Your ref: 2013/7426/P

RE: PROPOSED INSTALLATION OF 3 AIR CONDITIONING UNITS AND RELOCATION OF 2 UNITS AT THE FITZROY TAVERN, 16A CHARLOTTE STREET.

Project: 16 Charlotte Street The Fitzroy Tavern W1T 2LY

> Photograph Sheet

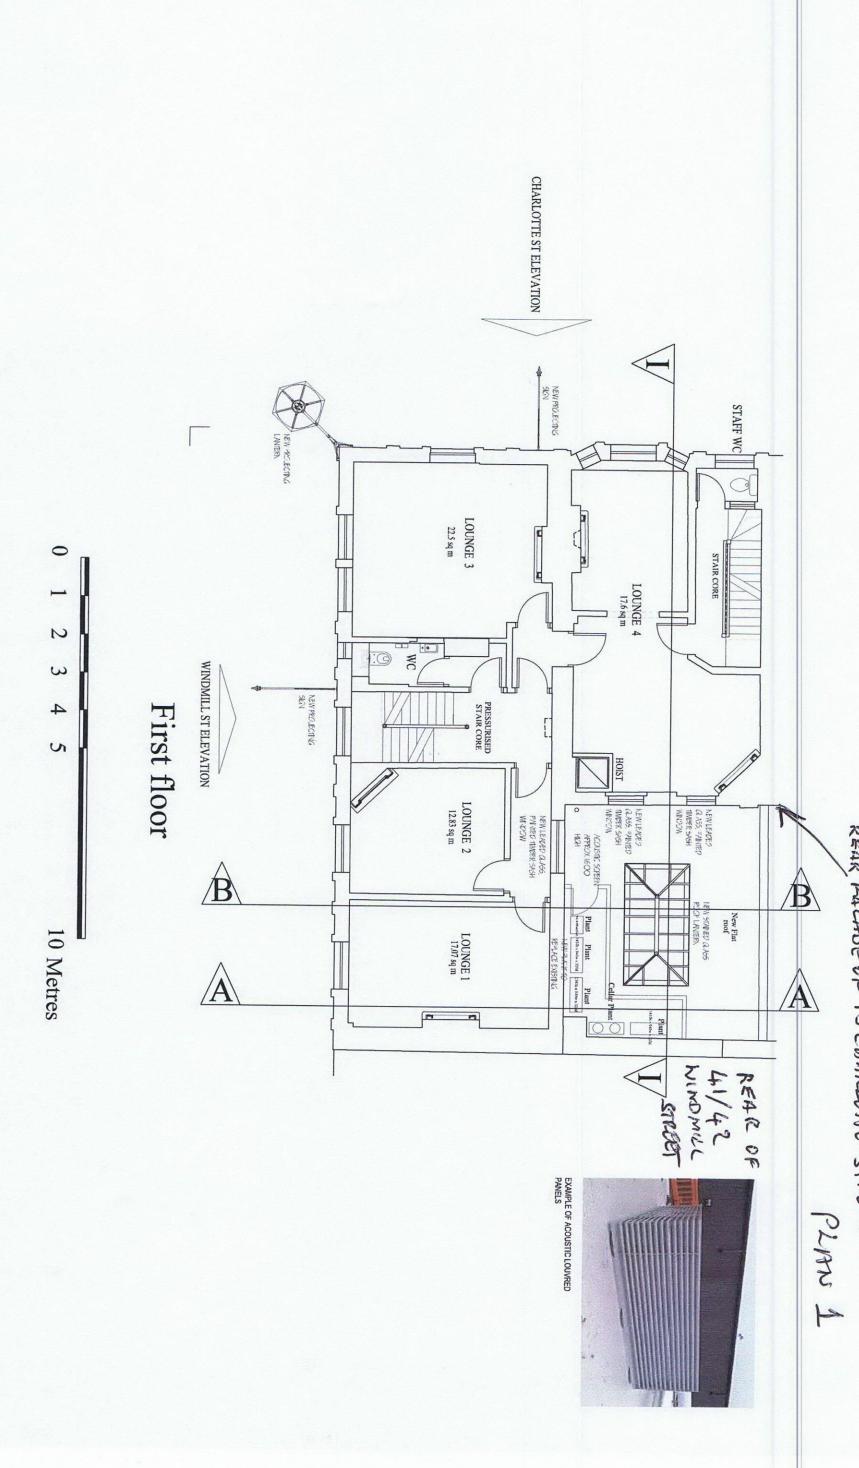
As you know, permission has recently been granted for an additional 4x condenser units and an air handling unit on the roof of 18 Charlotte Street, London W1T 2LZ (see photographs 1 and 2 attached) courtesy of application 2013/5908/P being allowed. The addition of another 3 air conditioning units on the roof of 16A Charlotte Street in such close proximity to the bedroom windows of 41/42 Windmill Street our client considers would make the habitable conditions within this property intolerable especially during the summer months when these windows would be likely to be open. A first floor plan of the proposal attached at Plan 1 shows the proximity of the proposed units to 41/42 Windmill Street.

WELLENGEN OF MODEL CHORD IN JUST BEEN 2013/5908/8 UNITS HAVE AIR HANDLING UNITS AND 4 consenser WHERE ANOTHER MINDMILL Rear flat roof of 18 Charlotte Street

View of neighbouring roof areas INCLUDING BEDROOM WALLOR 41/42
